# 1420 RIDGECREST DR. – Retroactive Approval of Windows and Rear Deck

## (H24-021-COA)

CITY OF HENDERSONVILLE - COMMUNITY DEVELOPMENT - HISTORIC PRESERVATION  
COA STAFF REPORT

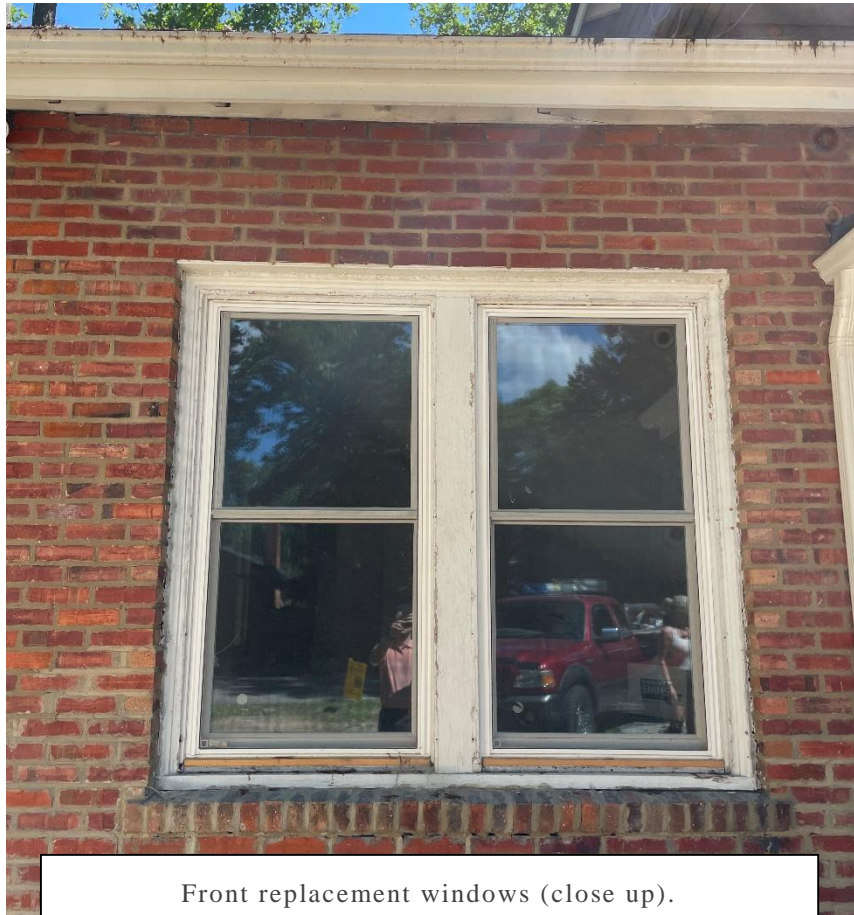
View of front façade of 1420 Ridgecrest Drive with the **previous windows.**

View of front façade of 1420 Ridgecrest Drive with the **replacement windows.**

Front replacement windows (close up).

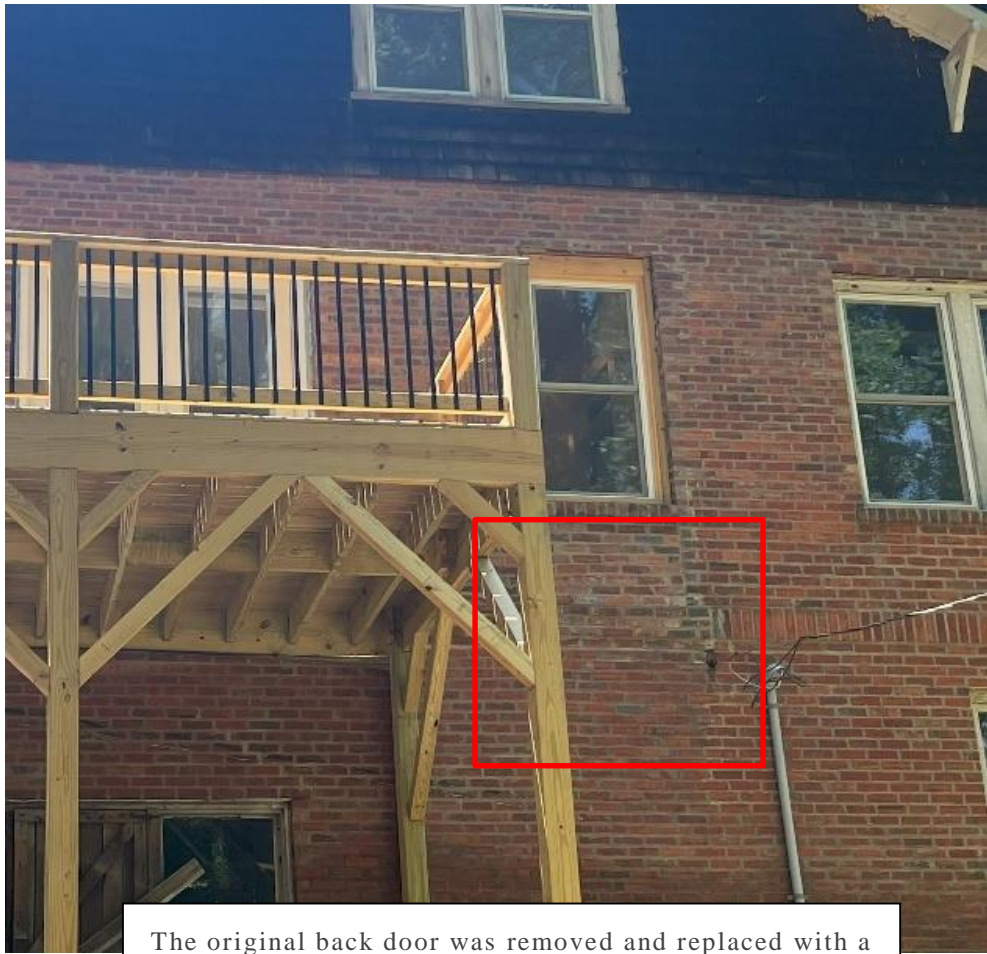
Rear of house. Replacement left window was enlarged. Window to the right of the double doors replaced the spot previously occupied by the back door.

The original back door was removed and replaced with a window. Brick was used to fill in underneath the window.

Left window opening on rear of house was increased in size to allow for a larger window.

The double doors on the rear of the house are located where two windows previously were. The property owner did not submit a COA for the double doors. Staff became aware of the doors while reviewing the current application and has requested the applicant submit an additional COA for the doors to be reviewed at the next HPC meeting.

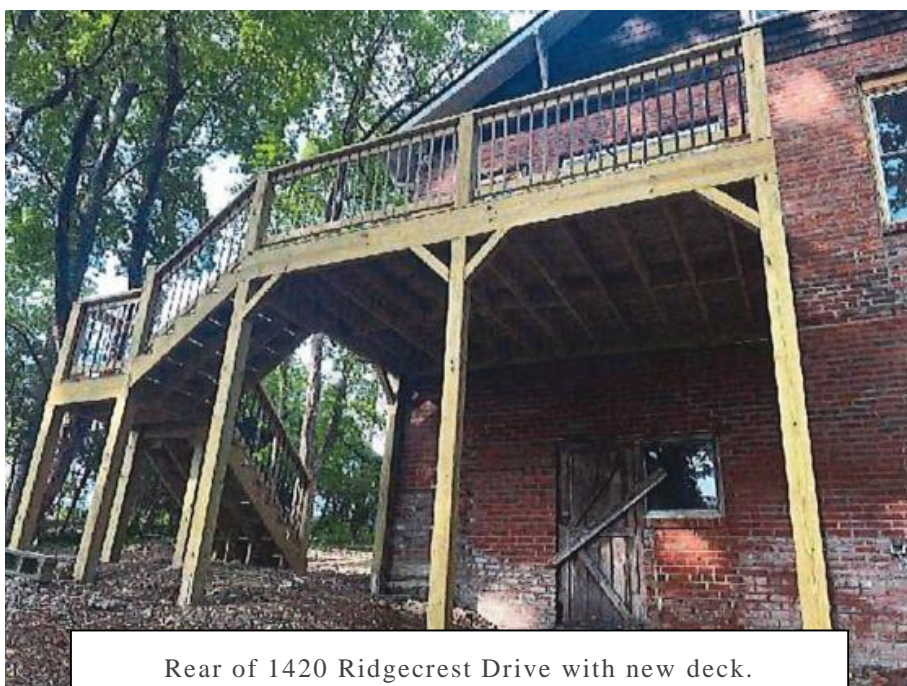
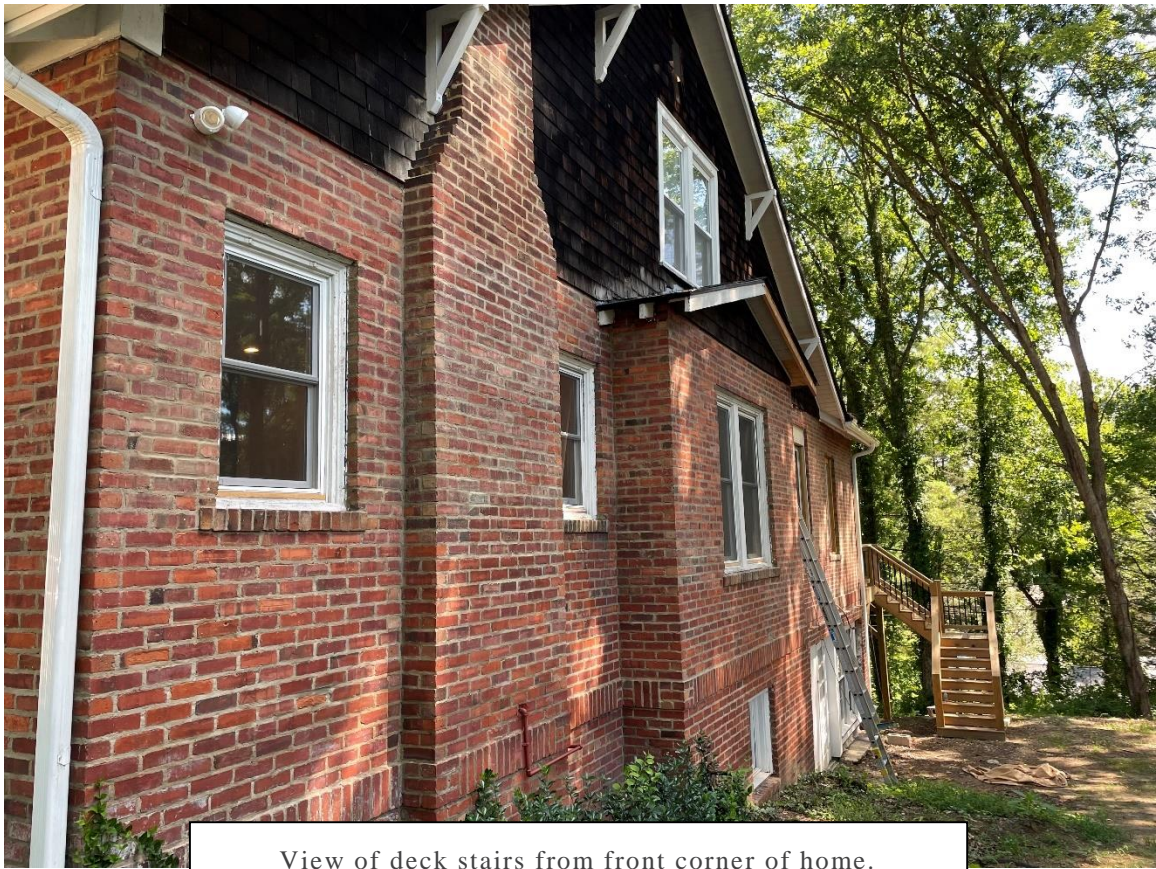
Rear of 1420 Ridgecrest Drive with previous deck and steps.

Rear of 1420 Ridgecrest Drive with new deck.
